NEW CB # 4

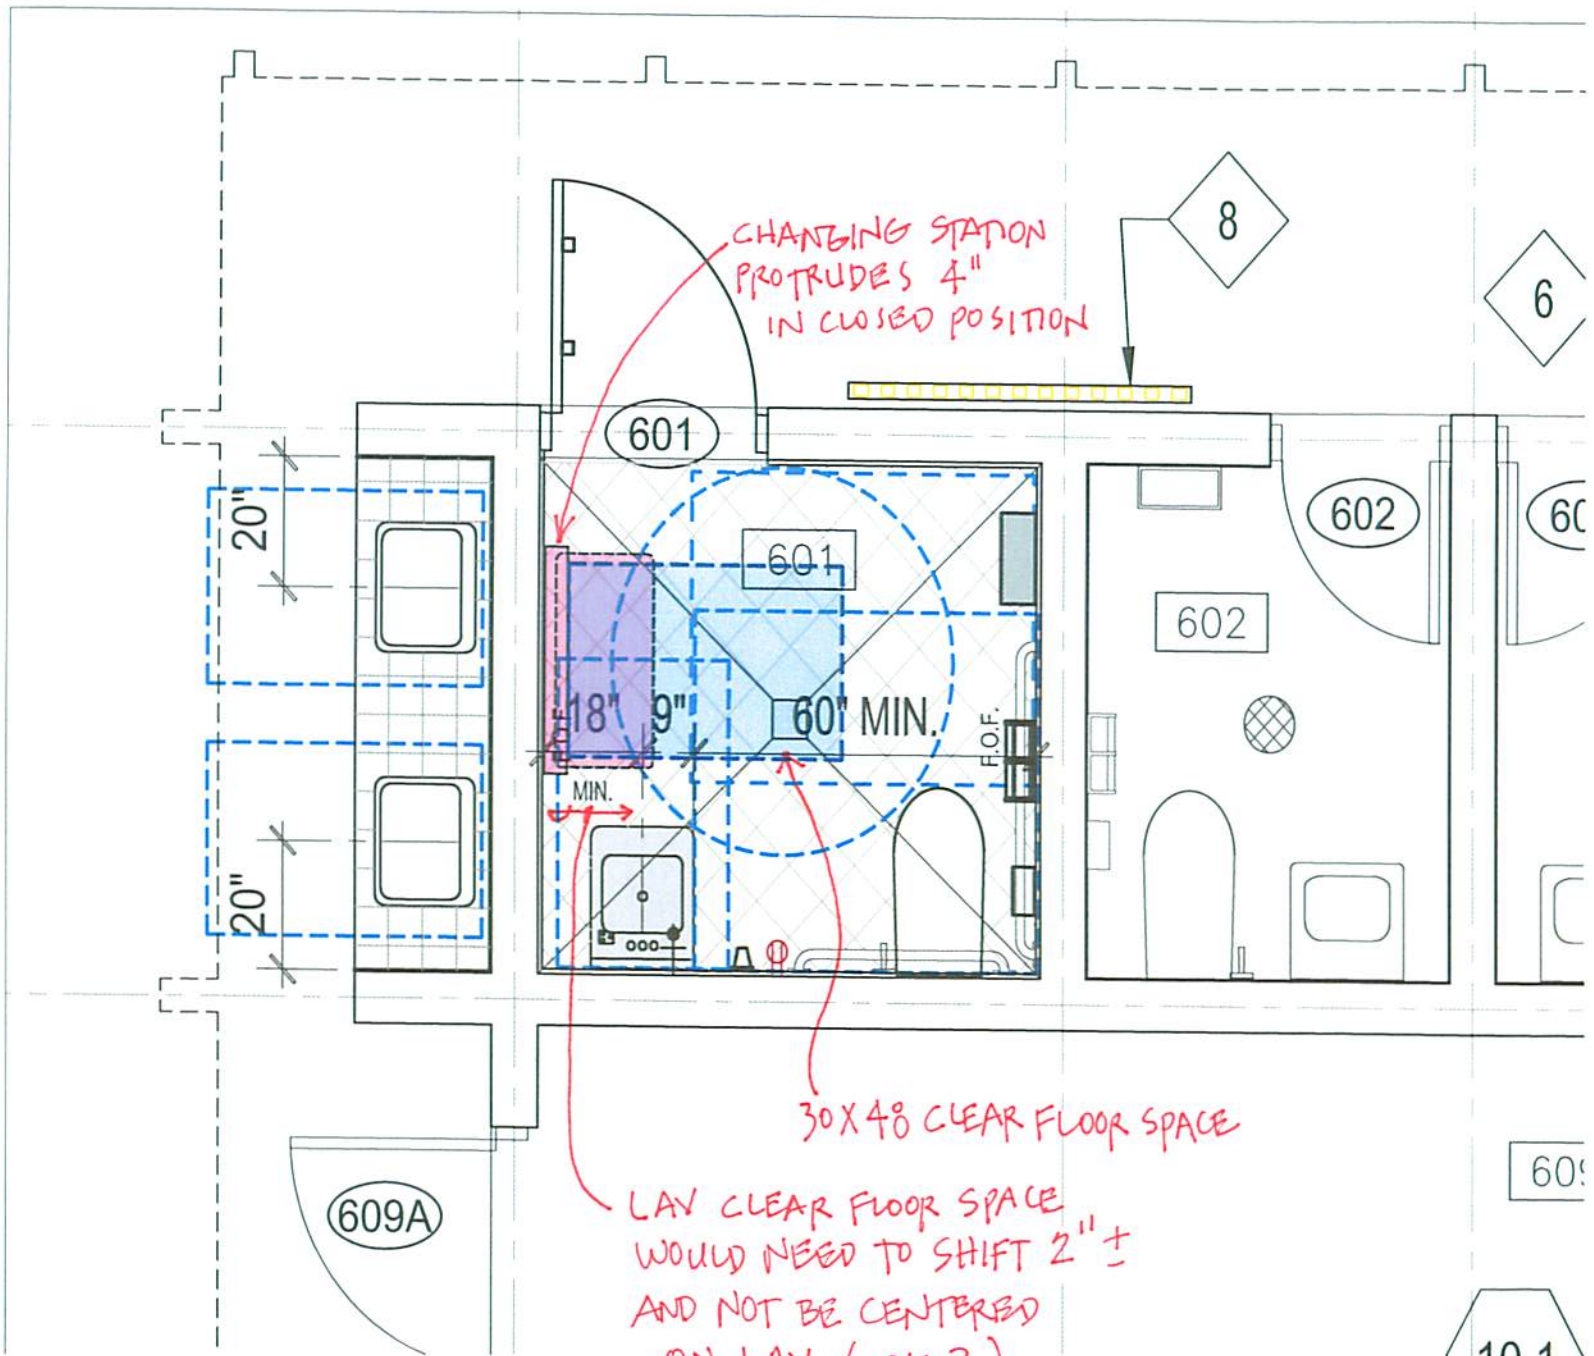
LAV CLEAR FLOOR SPACE
WOULD NEED TO SHIFT 2" ±
AND NOT BE CENTERED
ON LAV (OK?)

REMODELED CB# 6

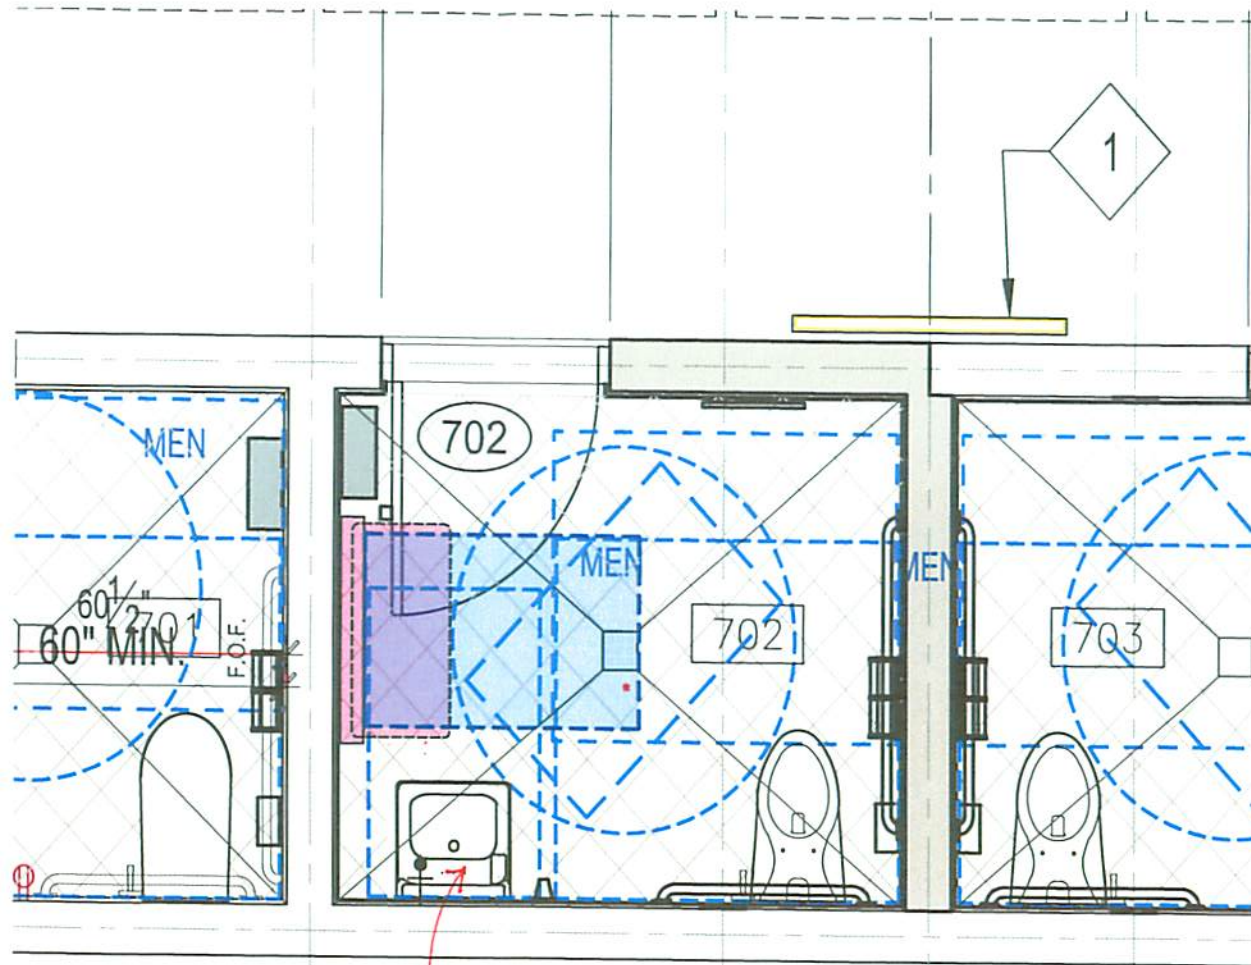
LAV SHIFTED
 FURTHER FROM
 WALL TO ACCOMMODATE
 4" CHANGING
 STATION
